**TOWN OF FAIRFAX
STAFF REPORT**
Department of Planning and Building Services

TO: Fairfax Planning Commission
DATE: May 21, 2020
FROM: Linda Neal, Principal Planner
LOCATION: 88 Toyon Road
PROJECT: New single-family residence and existing driveway improvements
ACTION: Hill Area Residential Development, Excavation, Tree Removal and Design Review permits; Application # 20-3
APPLICANT: Kenneth Holder, Architect
OWNER: David and Stephanie Russell
CEQA STATUS: Categorically exempt, §15303(a)

Re: Third Planning-Level Geologic, Geotechnical, and Civil Engineering Review
New Single-Family Residence
88 Toyon Drive (APN 003-081-39)
Fairfax, California

PROJECT NORTH
SITE PLAN-EXISTING / DEMO 1
1/8" = 1'-0"

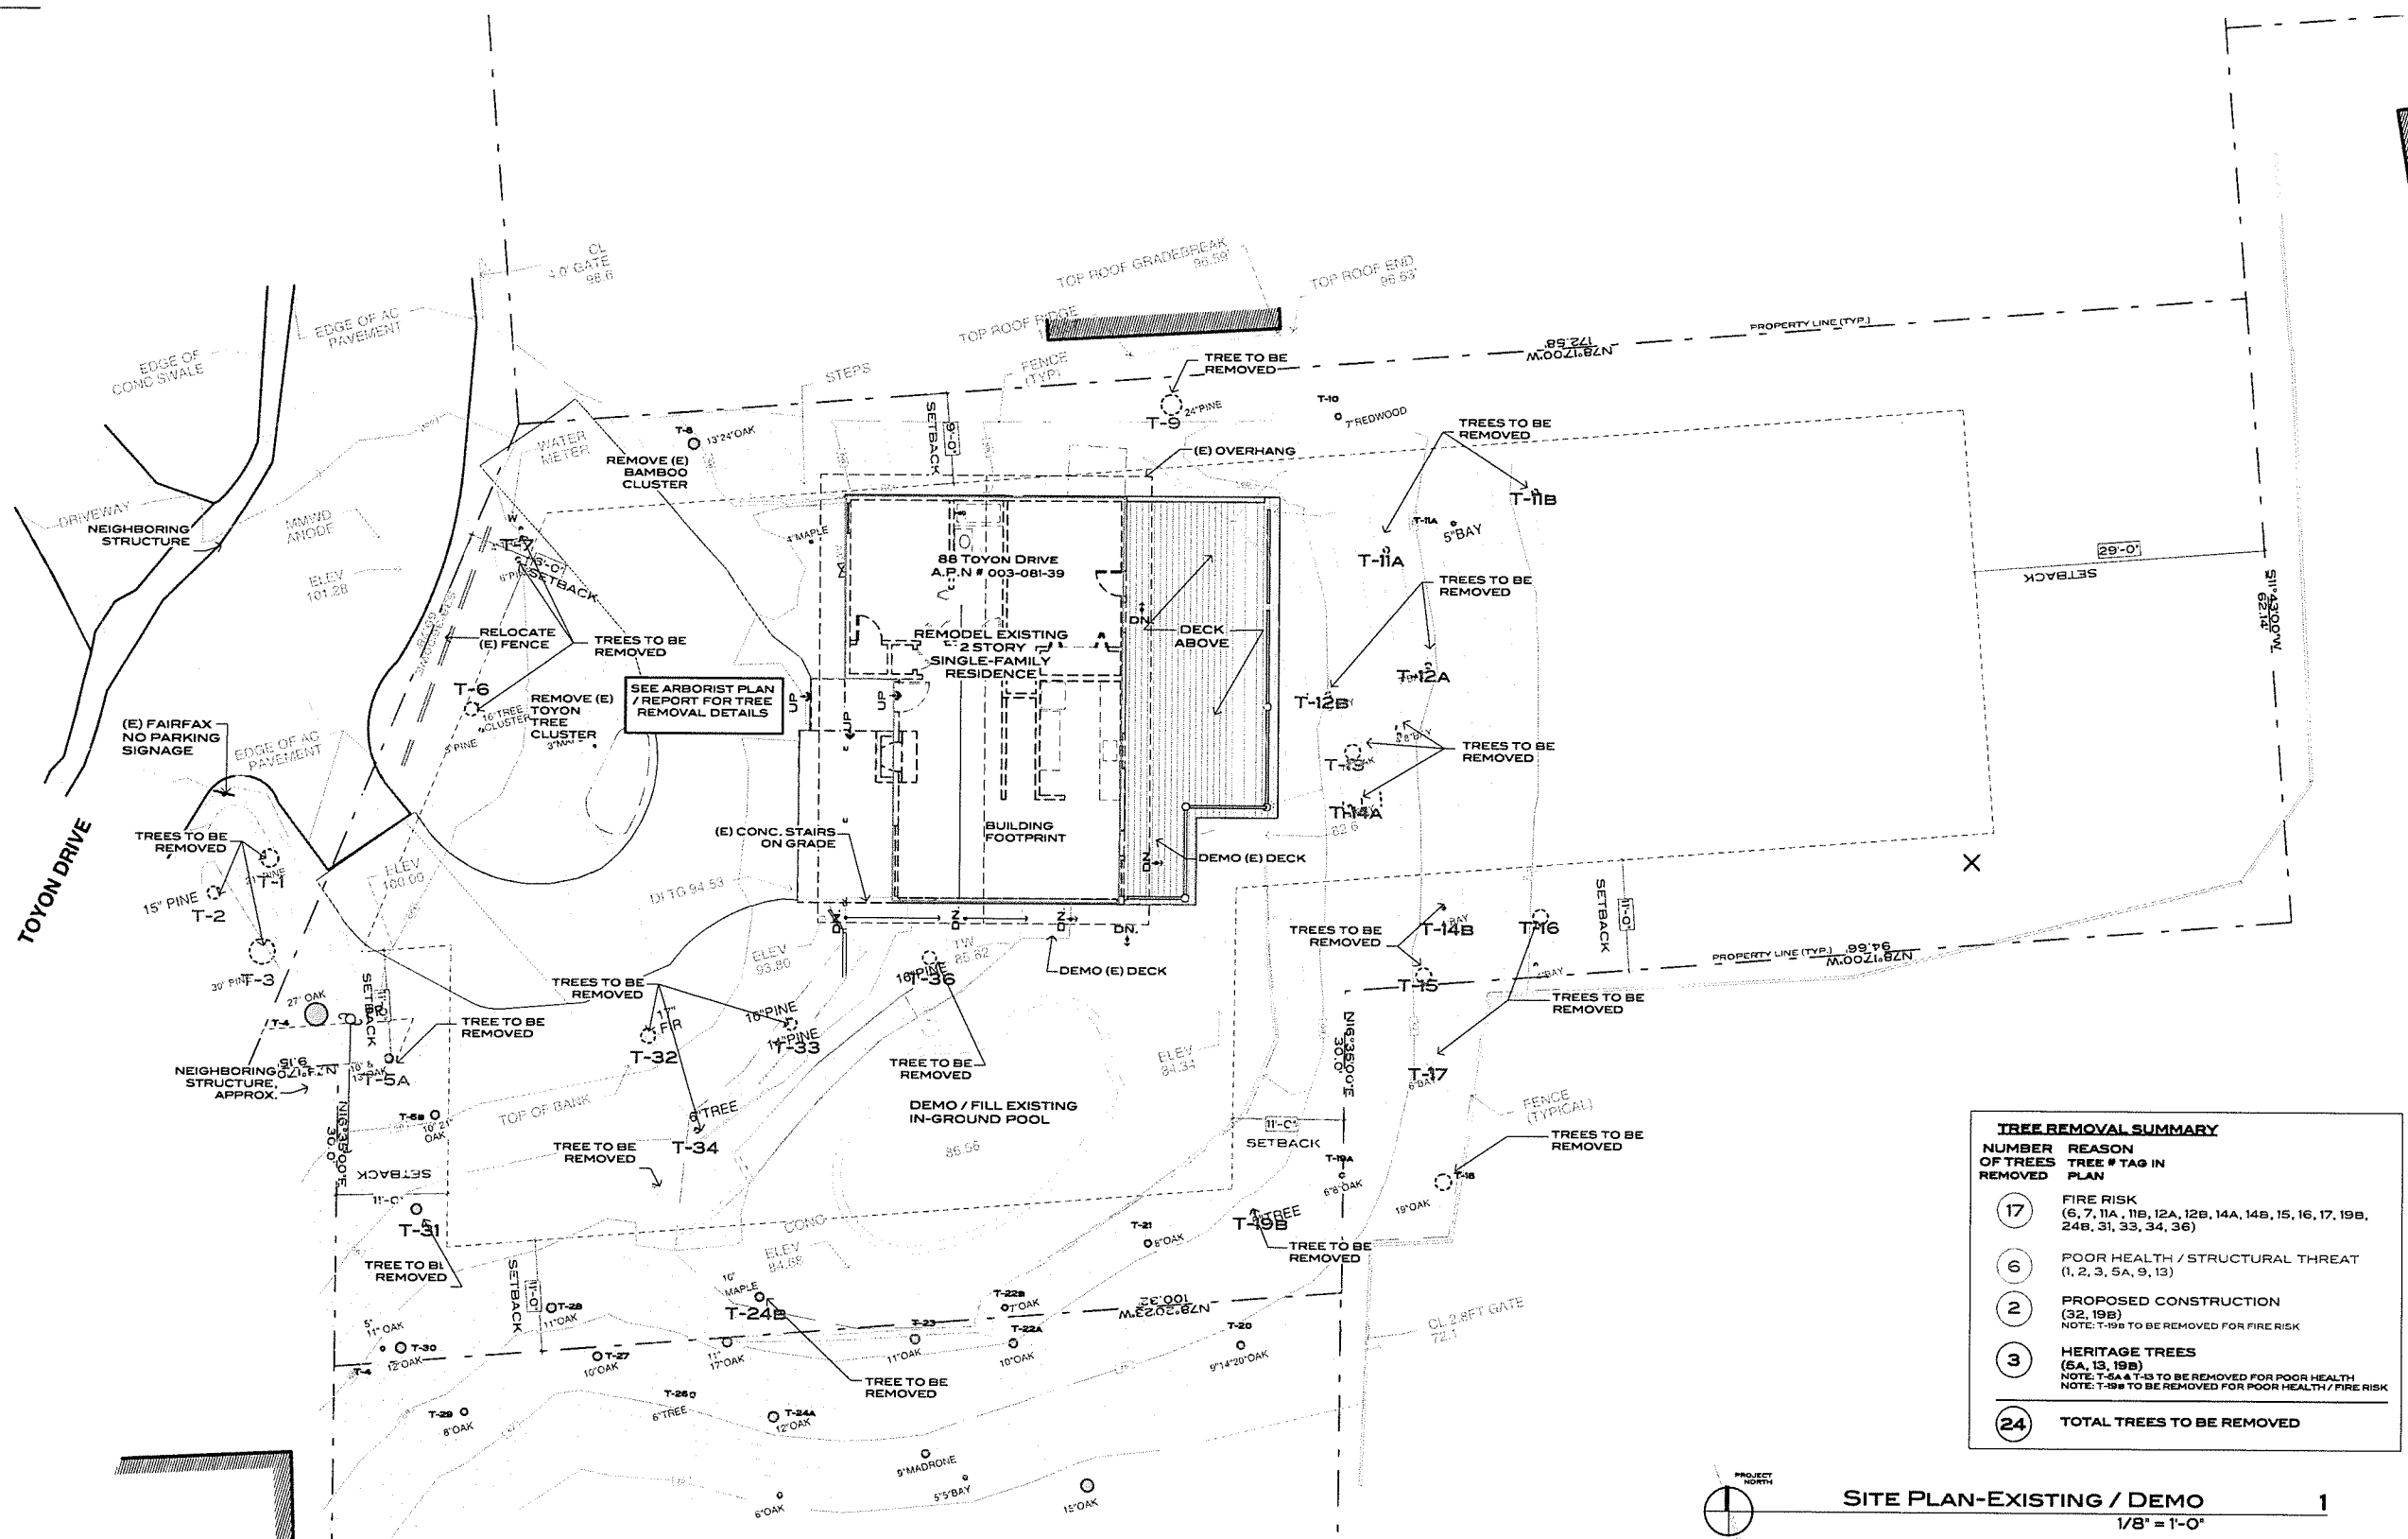
- Section 17.072.080(D)
 - 2) Project plans indicate 25 trees will be removed to accommodate the planned construction; therefore, a Fairfax Tree Committee report and permit must be obtained. We also note that the arborist map indicates "the entire property should be a defensible space zone". In light of the anticipation that "defensible space" likely requires removal of significant existing vegetation.

The arborist should define the required tree/vegetation removal process, and any needed stability/erosion-control measures should be provided on the plans.

SITE PLAN-PROPOSED
1/8" = 1'-0" 1

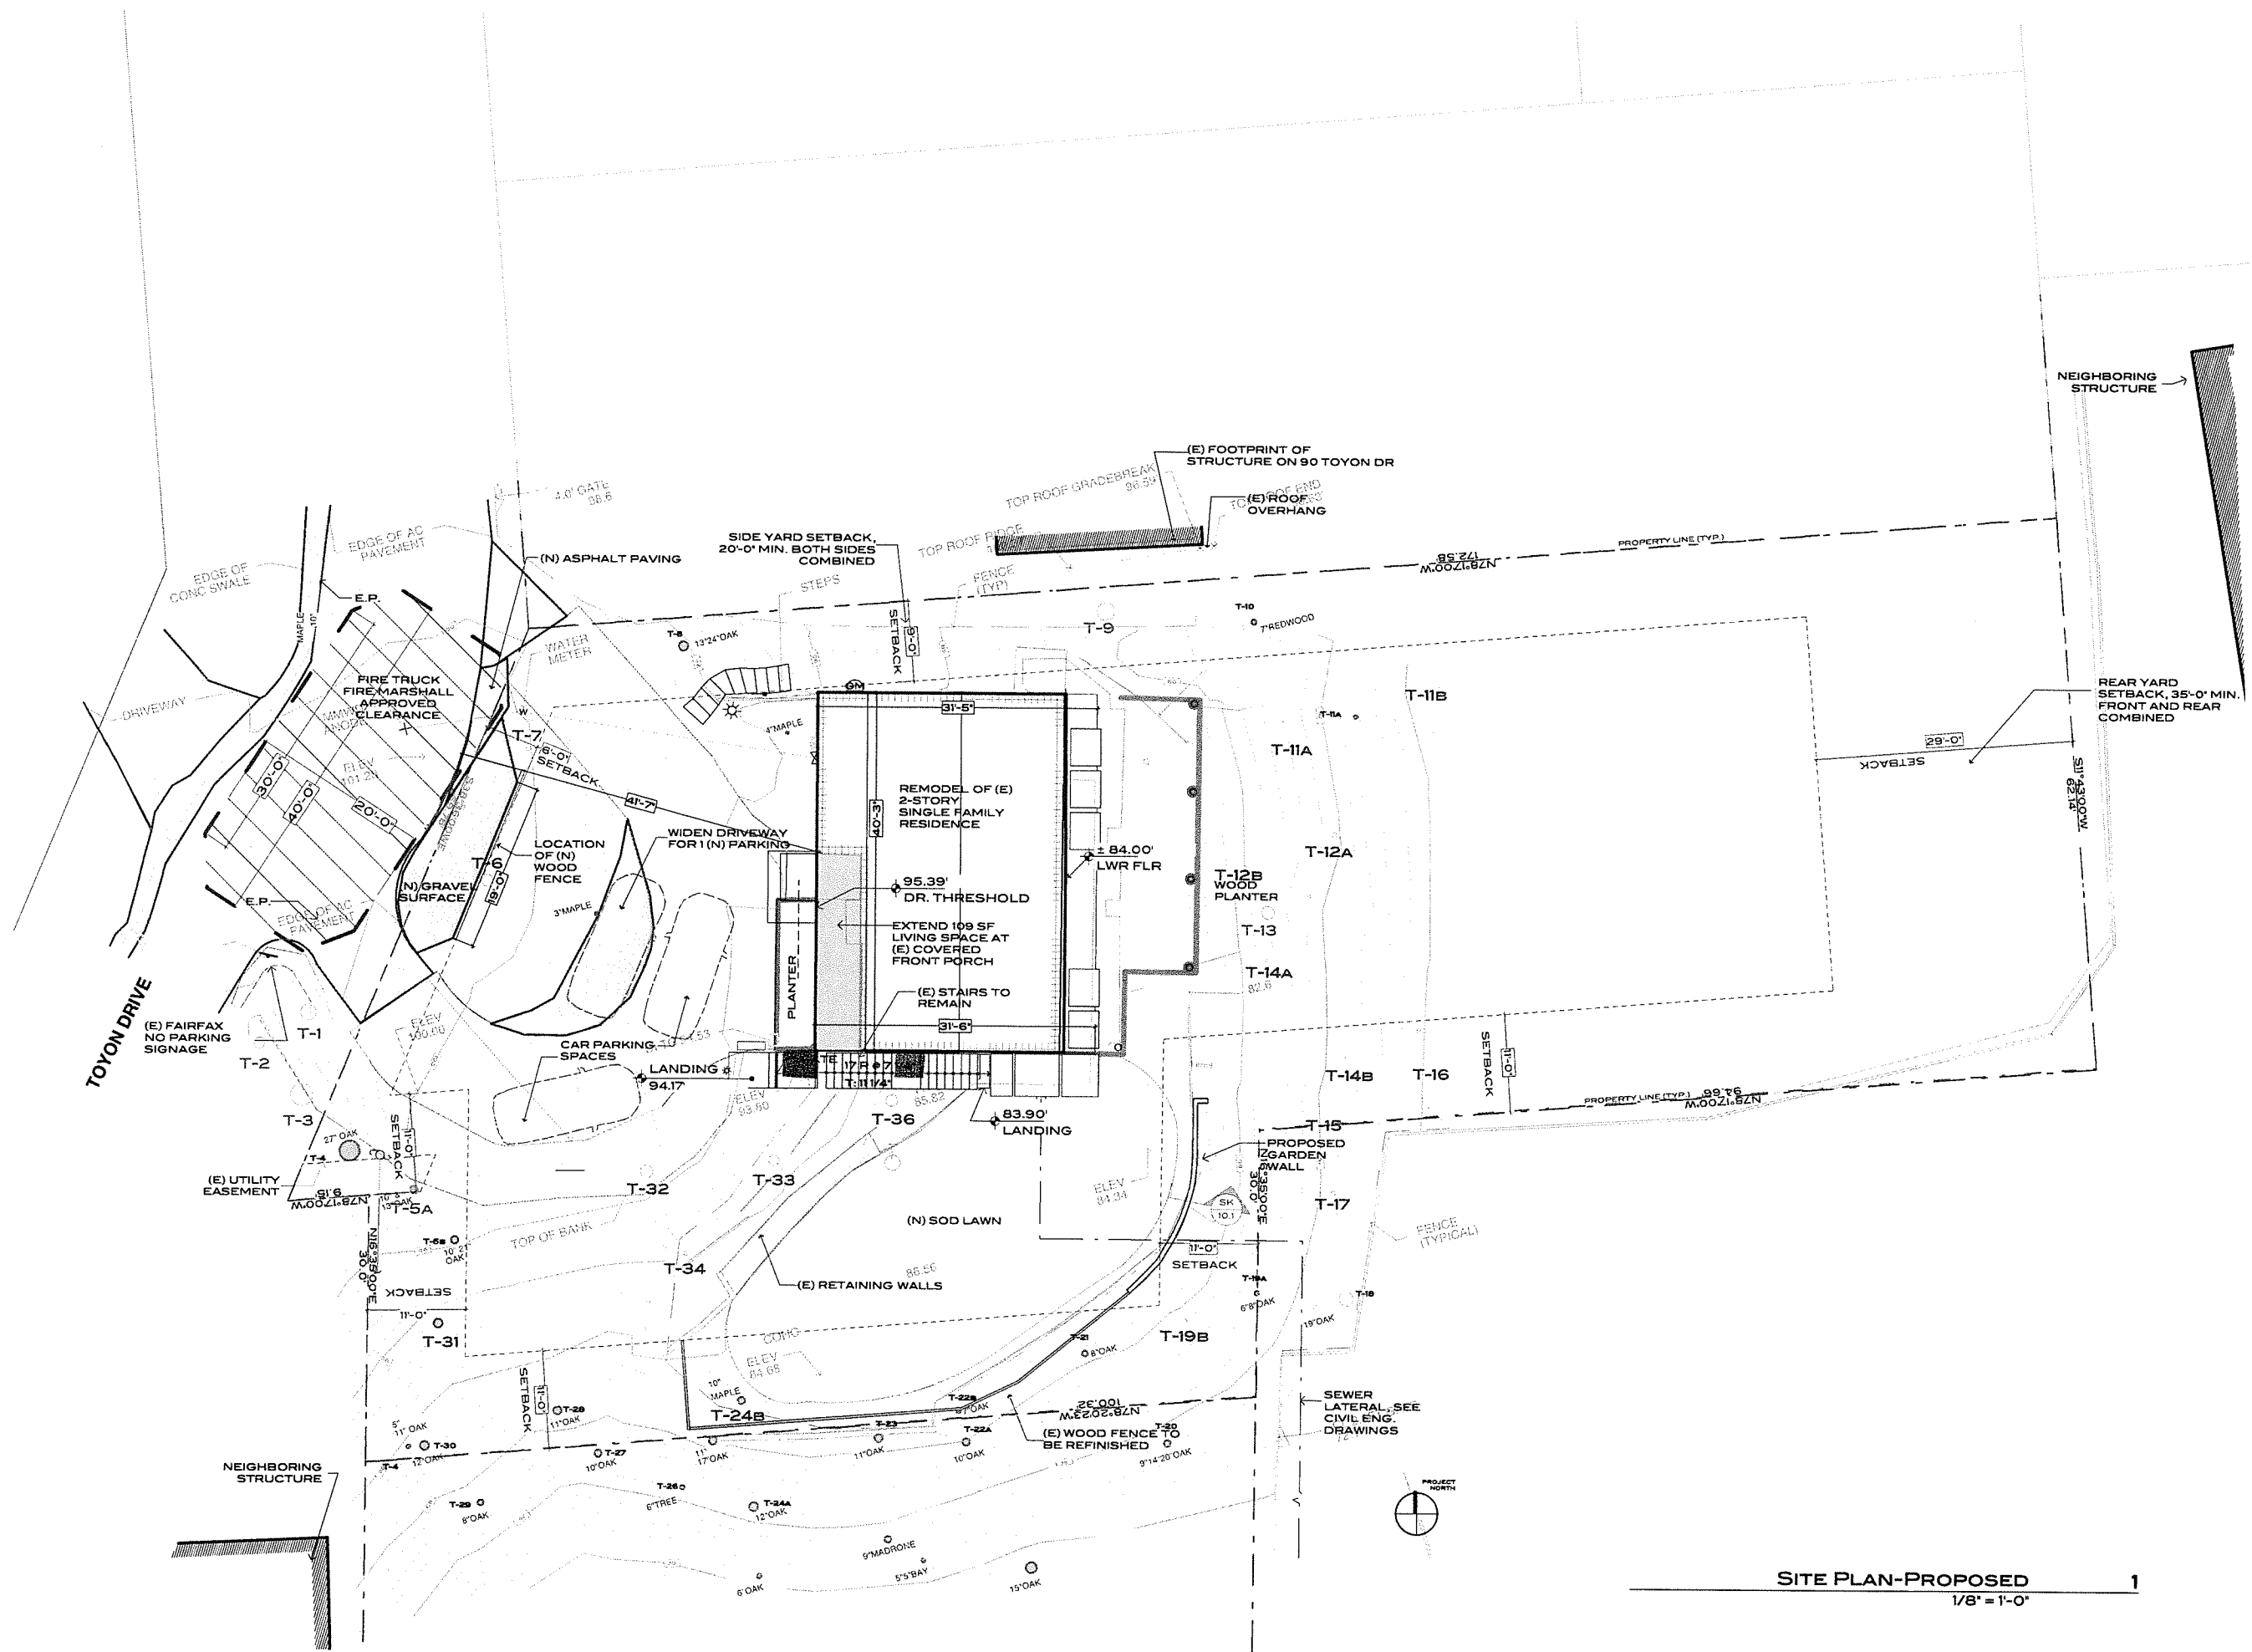
- Section 17.072.080(C)
 - 1) Project Architectural plans (Sheet A1.1) indicate asphalt paving and a new gravel shoulder will be installed in the Toyon Drive right-of-way to accommodate required fire access. We note that the gravel surface is not shown on the Civil plans, and appears as though it may require relocation of existing street signage and other improvements in the right-of-way. Plan should be revised to include the proposed gravel shoulder and indicate any ancillary work required. An encroachment permit should be required for all work in the right-of-way.
